RE: Stage 9 Tailings Storage Facility Construction Drawings and Stability Analyses for Embankment Raise to El. 970 m

**Mount Polley Mine
Tailing Storage Facility
Stage 9 (970m) Expansion Stability Analyses**

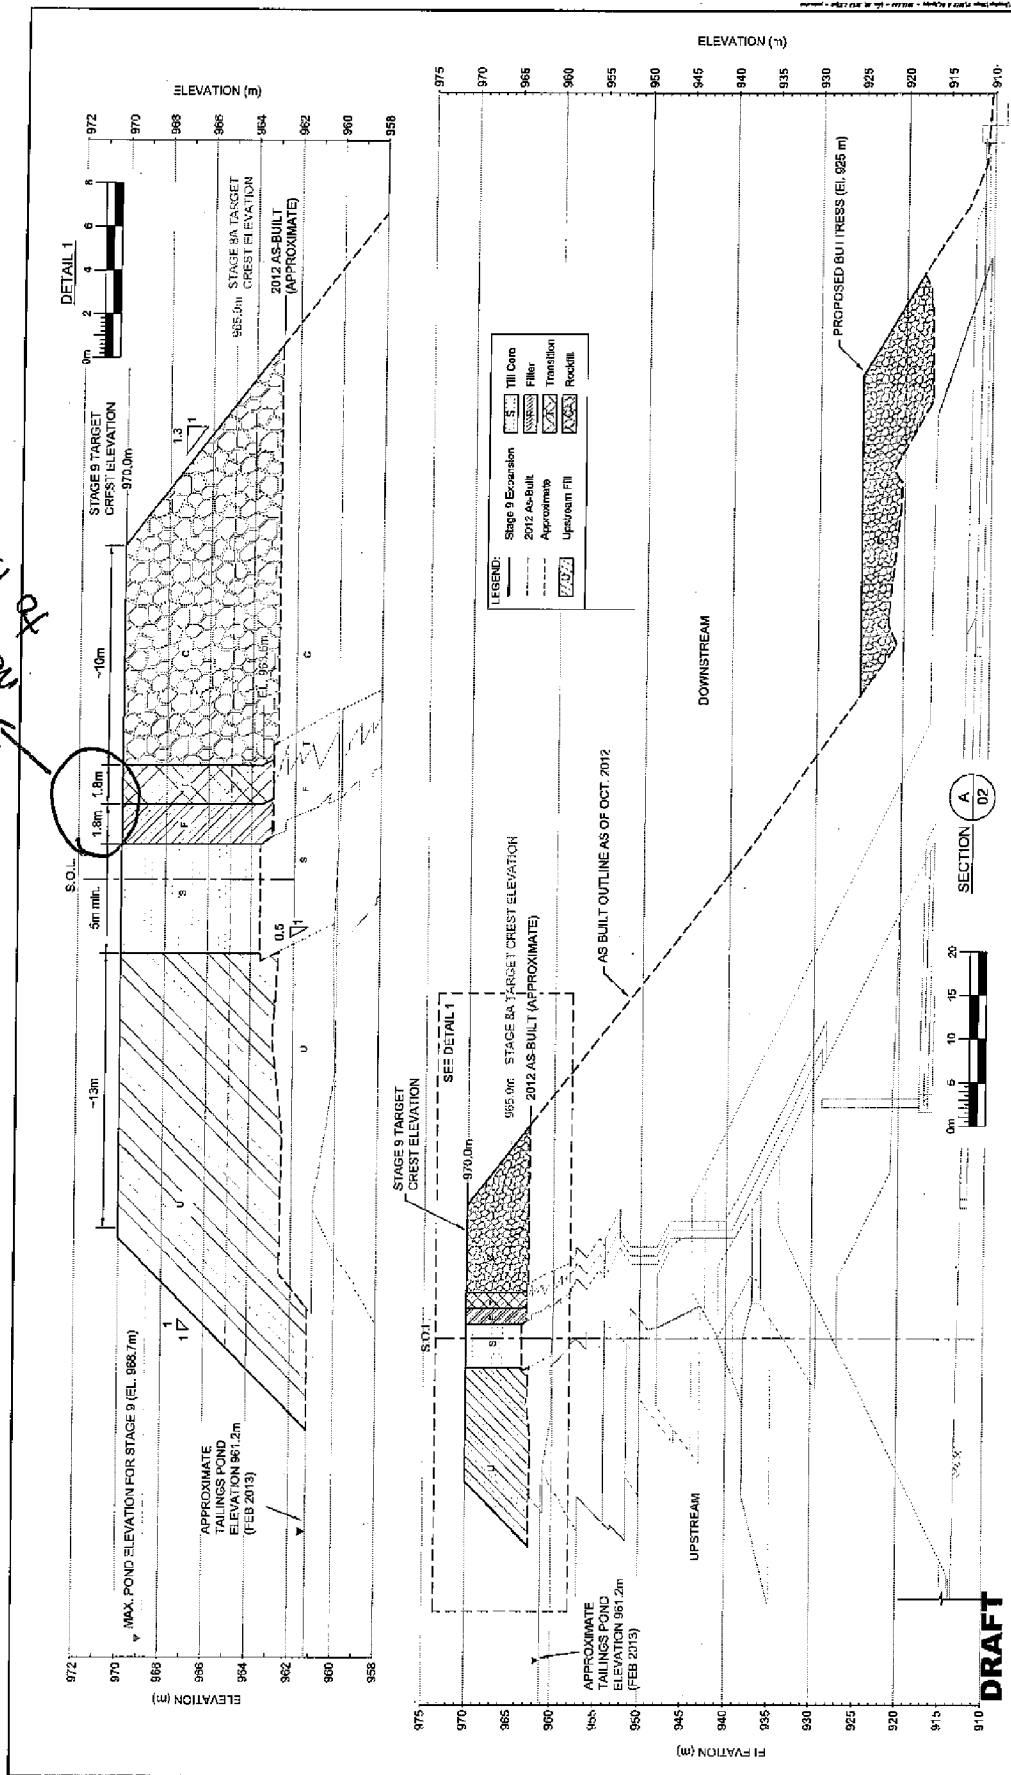
one we not gonna? to 15m

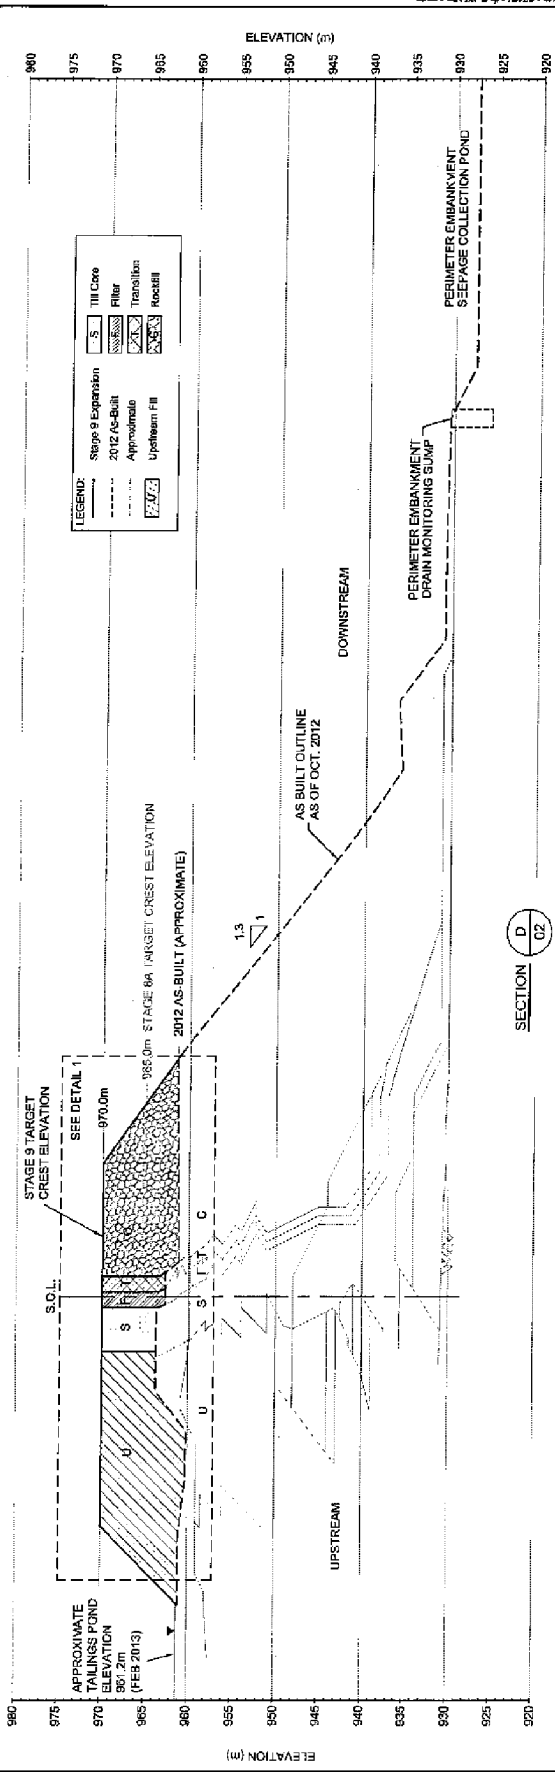
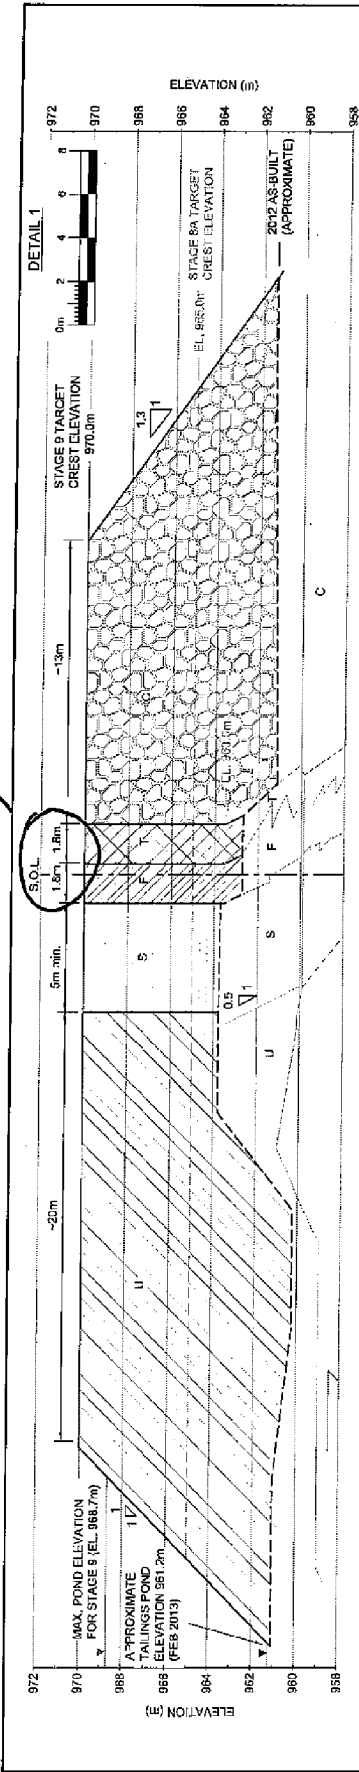
15m? →

STAGE 9 SOUTH EMBANKMENT SECTION F (7-20)

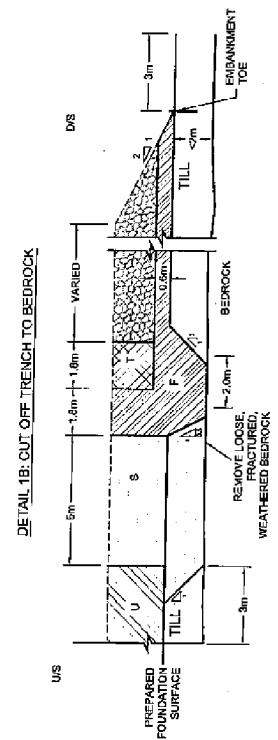
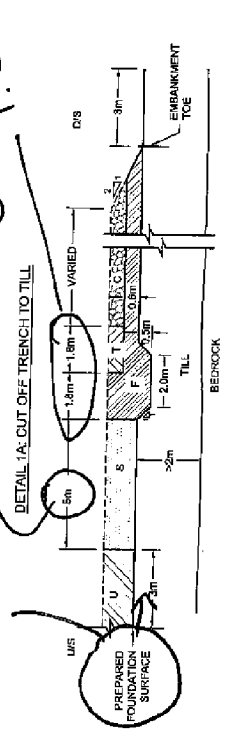
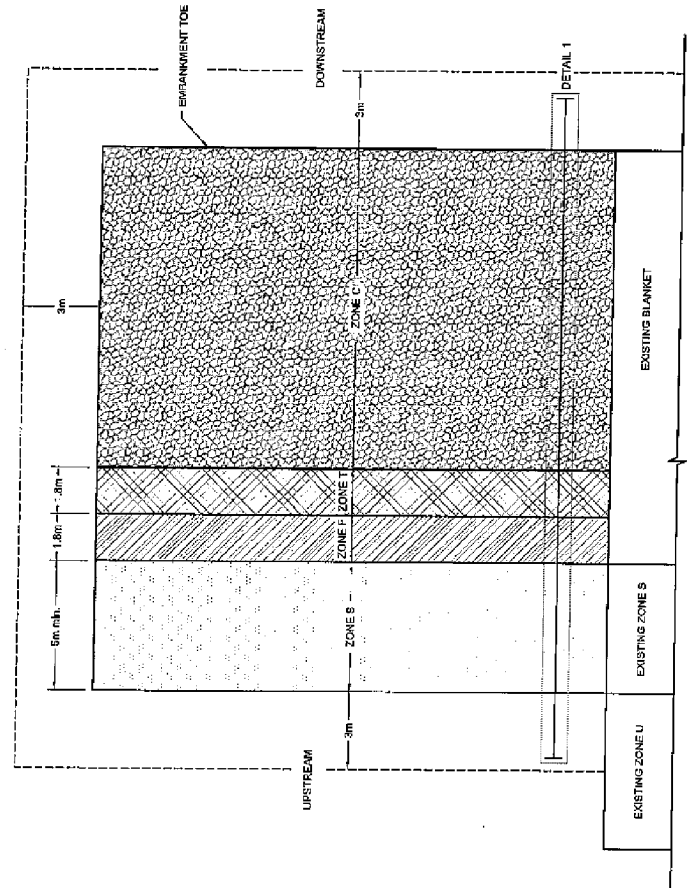
INTO ZONE C
 TOO ? IS THIS A MIN.
 TO MATCH EMBANKMENT
 @ 6.0m? OR IS IT CONTROLLED?
 1.5m?

STAGES 9 TAILINGS EMBANKMENT NOTES & SPECIFICATIONS

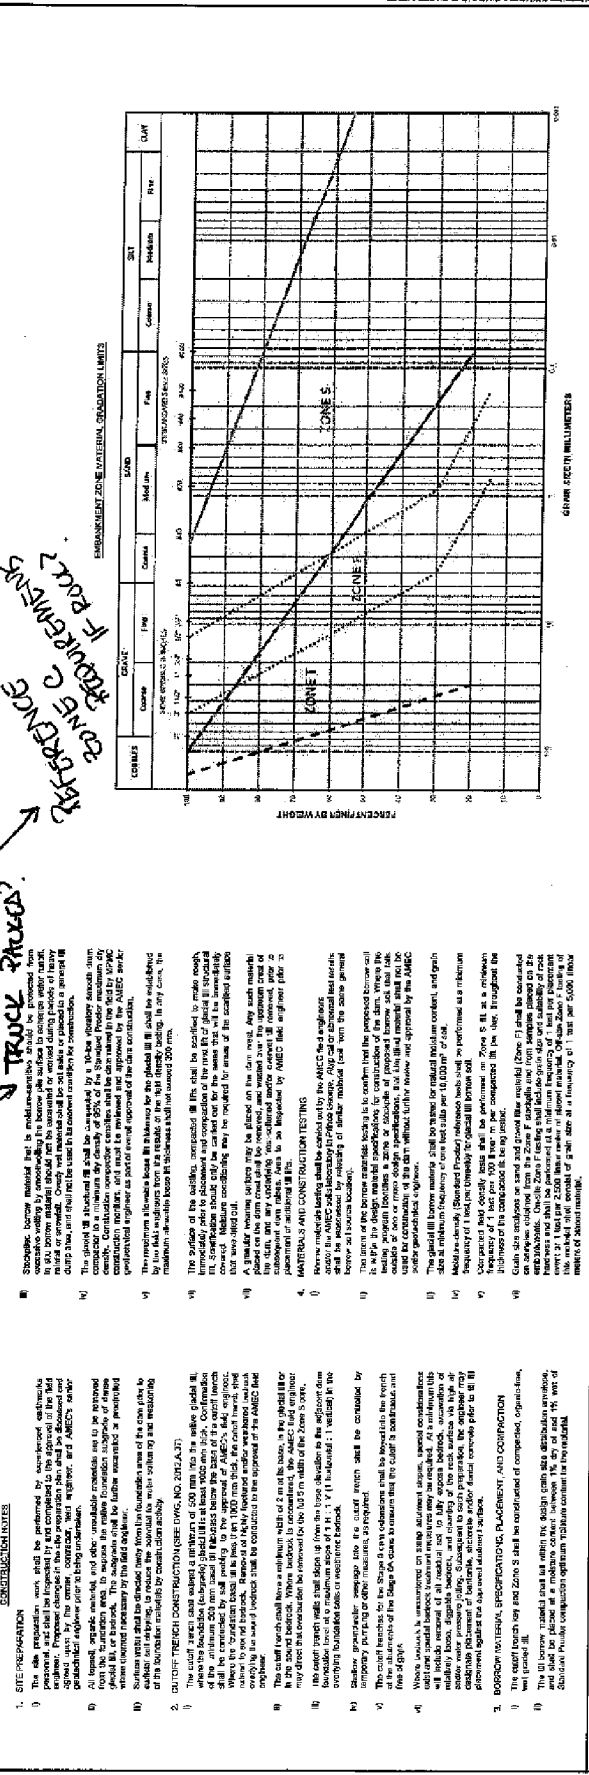
IS THIS A STATEMENT OR REQUIREMENT

TRUCK TRUCKS? REFERENCE TO CONE C REQUIREMENTS IF PACT?

YES IT BELONGS TO BETTER WAY, NOT NO CONCRETE
